**GULF STATES UTILITIES COMPANY**

River Bend Station - Unit 1

Docket No. 50-458

### RESPONSE TO SER OPEN ITEMS (10) AND (16) AND CONFIRMATORY ITEM (51):

Nuclear Document Control  
 MAR 29 1984

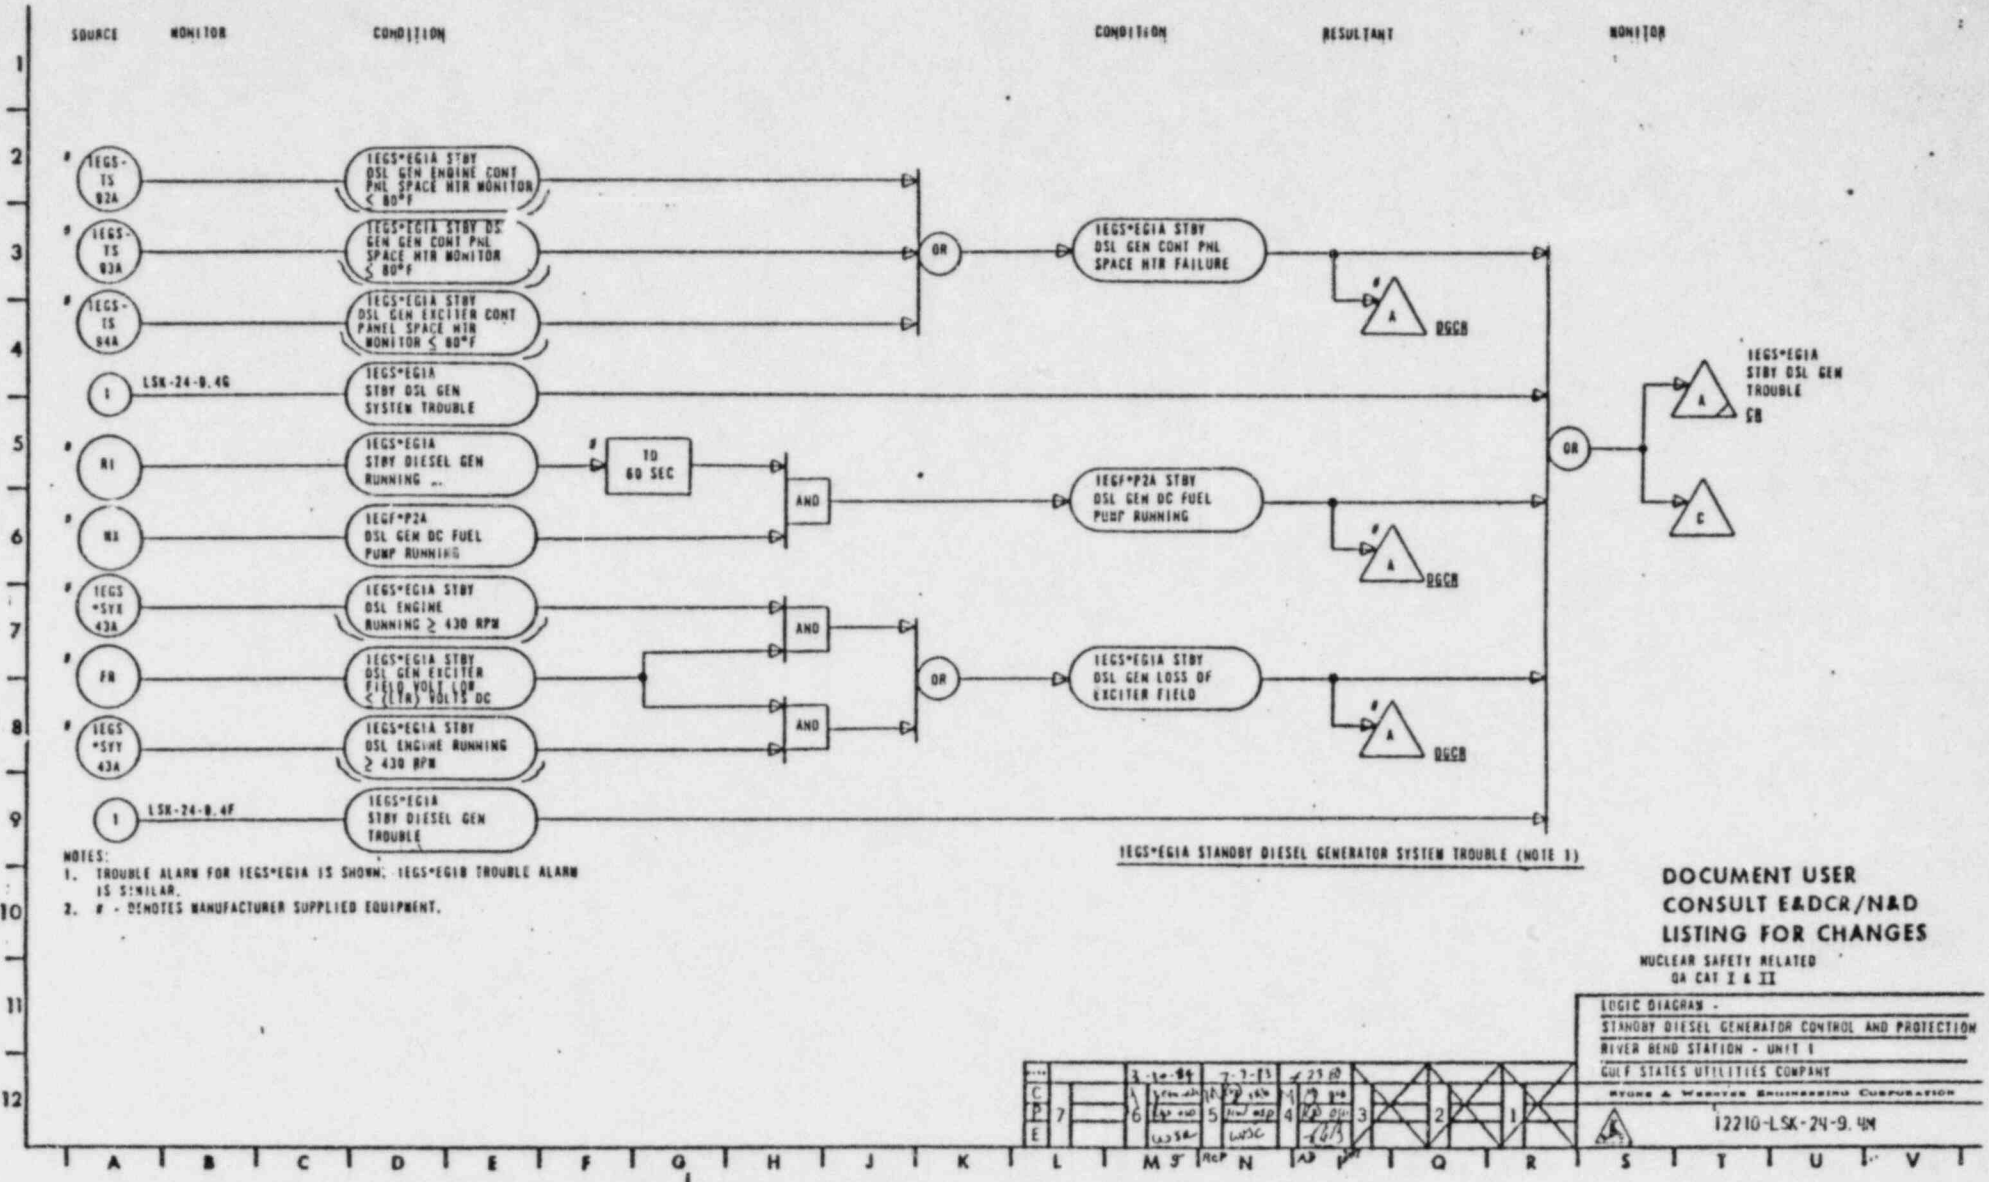
VIII DGSS I&C DRAWINGS

The standby diesel generator air start system instrumentation and controls diagram is provided in Enclosure 8. These drawings will be incorporated into the FSAR in a future amendment.

HPCS DGSS - FIVE START CAPABILITY

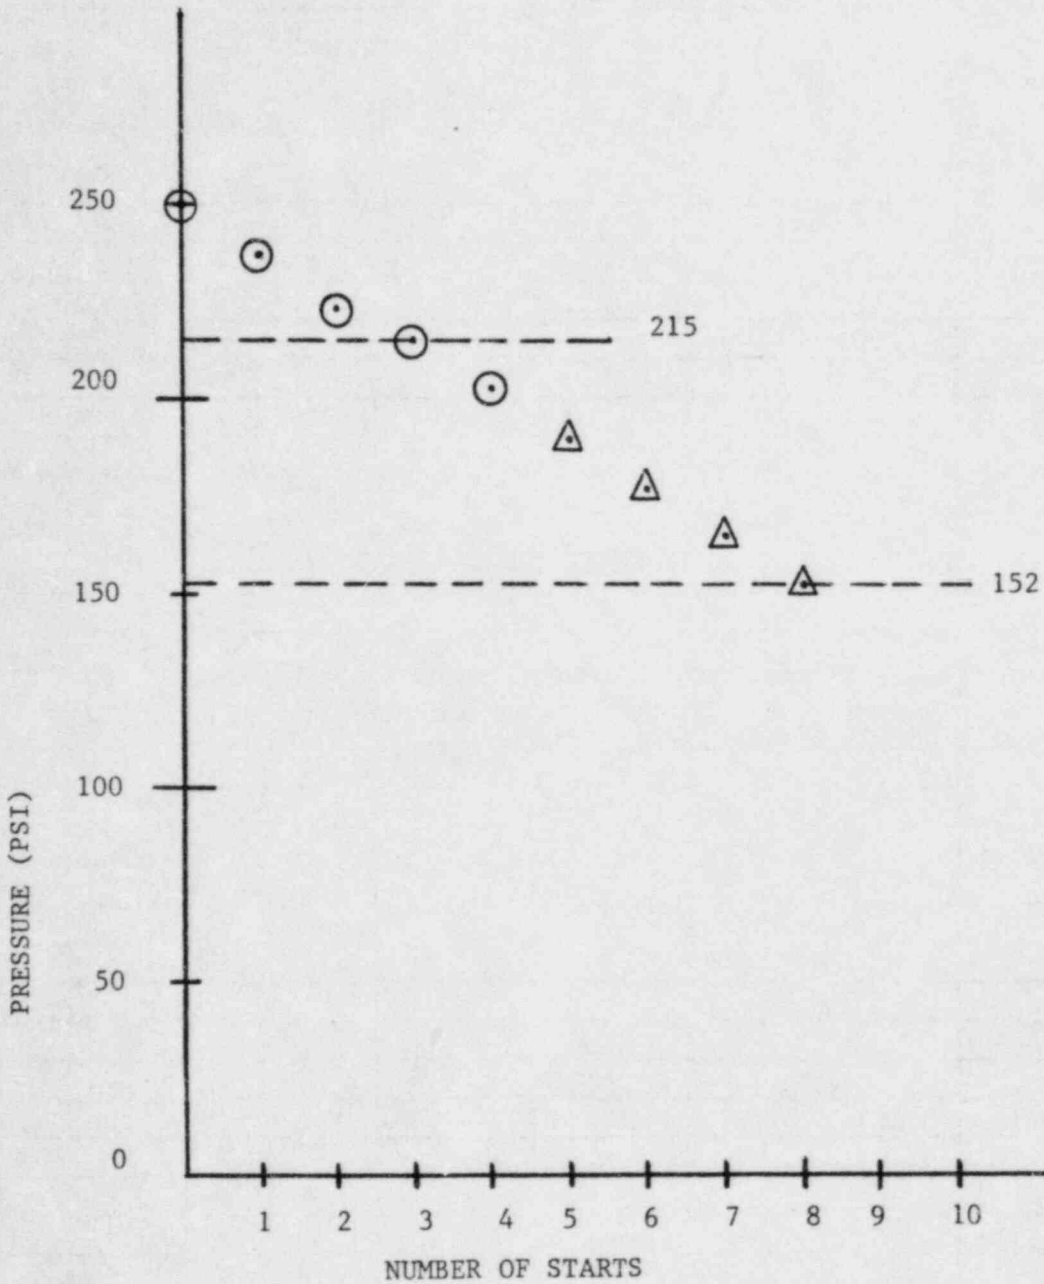
IX HPCS DGSS FIVE START CAPABILITY

Additional information on the five start capability of the HPCS DGSS is provided in revised FSAR Section 9.5.6.1 (Enclosure 9). A graph is provided in Enclosure 10 to show the HPCS DGSS five start capability based on a Perry factory test report. The extrapolated data points were based on a constant pressure drop determined by the mean of the actual test points. The constant pressure drop was used to determine the extrapolated points because the actual pressure drop would tend to decrease. Thus, the straight line curve would be conservative. In addition, as stated on FSAR Figure 9.5-4b the minimum recommended cranking pressure at the air starters is 100 psig.

△ Extrapolated data points are based on the starting curve trend. Five starts: beginning pressure 215 psi ending pressure 152 psi

FIGURE 9.5-9

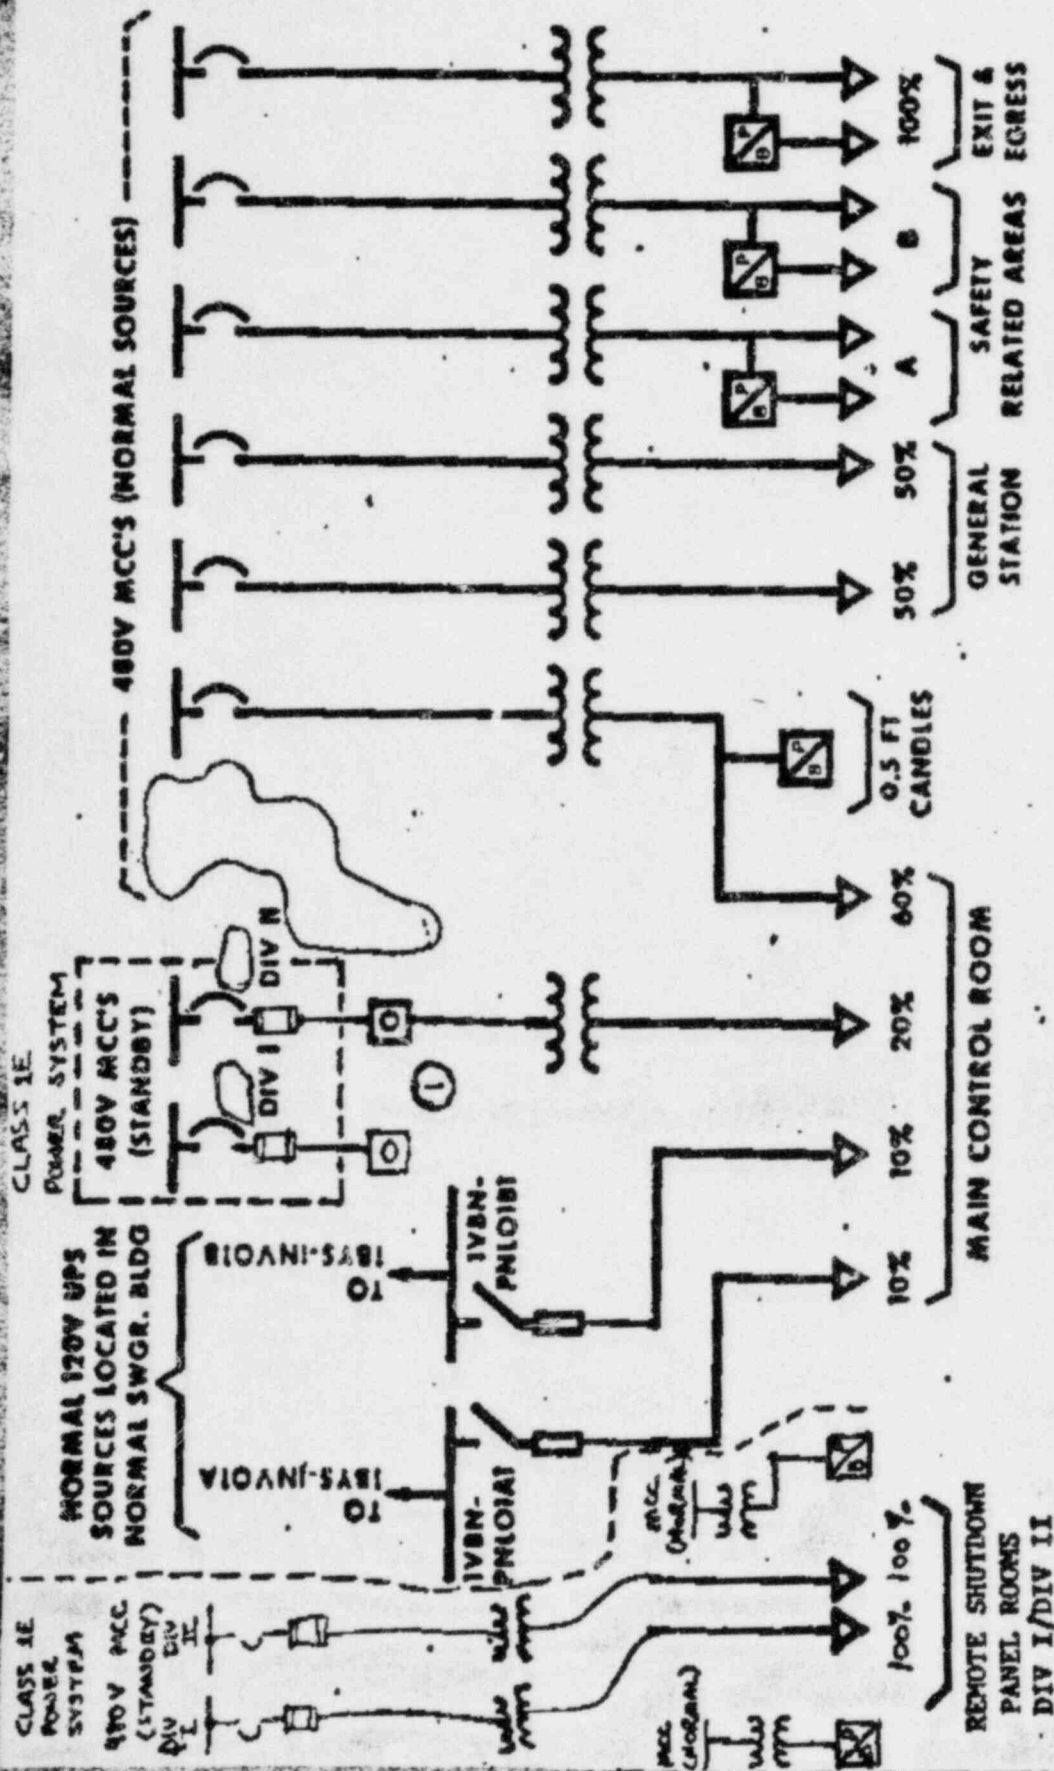
#### XI EMERGENCY LIGHTING

Additional information is provided in revised FSAR Section 9.5.3 and Figure 9.5-9 (Enclosure 10).

~~Because~~ The remote shutdown panel rooms and 20 percent of the main control room fixtures are connected to a Class 1E bus. Special design considerations have been made. From the Class 1E bus to ~~and including~~ the power receptacle, the circuit is designed as Class 1E with two independent overcurrent protection devices installed in the circuit to ensure protection of the Class 1E portion of the circuits. From and including the plug, it is treated as a non-Class 1E system, with additional safety protection as follows:

**INSERT A**
